EMBREY BUILDERS, LLC.

RFI #: 56
Date: 2/20/2012
Job: EB-02 Keller Springs Lofts
Phone: 877-777-5115

Subject: Party Walls

RFI #: 57
Date: 2/20/2012
Job: EB-02 Keller Springs Lofts
Phone: 877-777-5115

15
S4.03
STAIR LANDING SECTION
NO SCALE

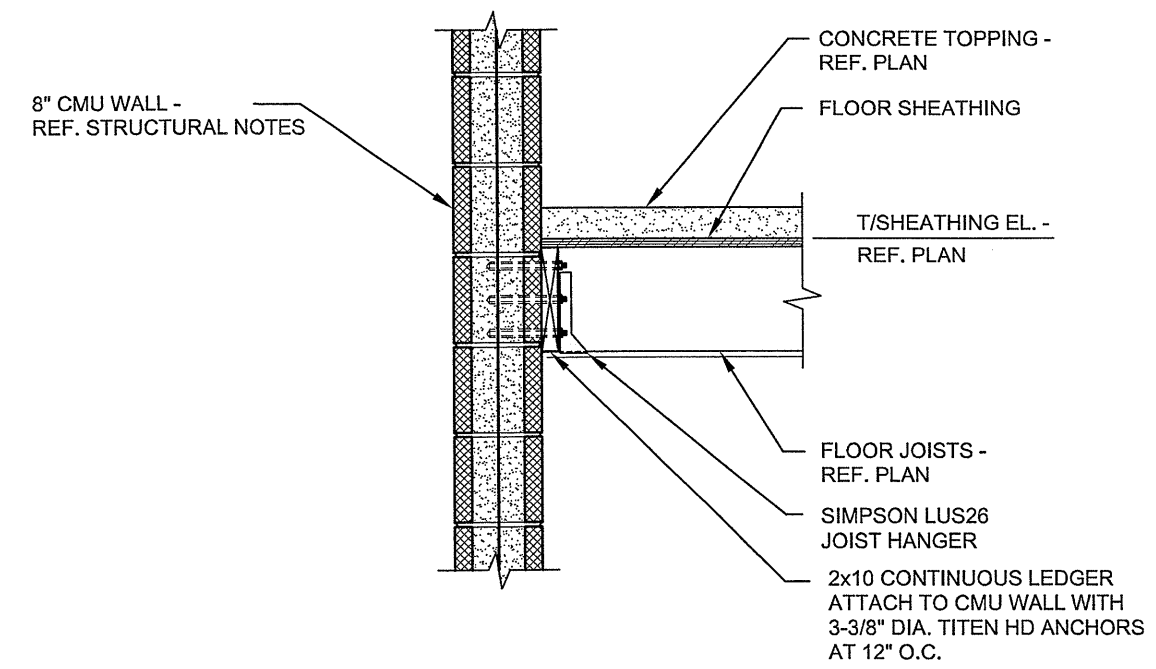
We have some questions concerning the CMU stair towers #4 & #5. (1) Page S2.24 has a cut through stairwell #4. This cut directs us to detail #6 on page S2.07. Detail #6 directs us to details #14 & #15 on page S4.02. These details (14 & 15) are wood to wood connections. We will need a wood to CMU connection detail for this application. (2) I have not seen a detail for the window in CMU application. Will there be 2x framing in the window openings? We would also like to confirm that the landings in the 2 CMU stair towers are in fact wood. It has been our experience that the landings in these type assemblies are usually metal.

yes it is acceptable to use 2x blocking for the windows
Erik Earnshaw 03-07-2012 BGO

Landings at CMU stair towers are to be wood framed.

Please see attached details for attachment of 2x landing framing to CMU walls.

Wood beams at the that support the stair stringers shall be attached to the CMU wall with HU410 beam hanger fastened to CMU wall with 18-1/4x2 3/4" Titen HD anchors installed in accordance with the manufacturer's recommendations. All vertical cells in CMU walls at beam hangers shall be fully grouted over the height of the wall.
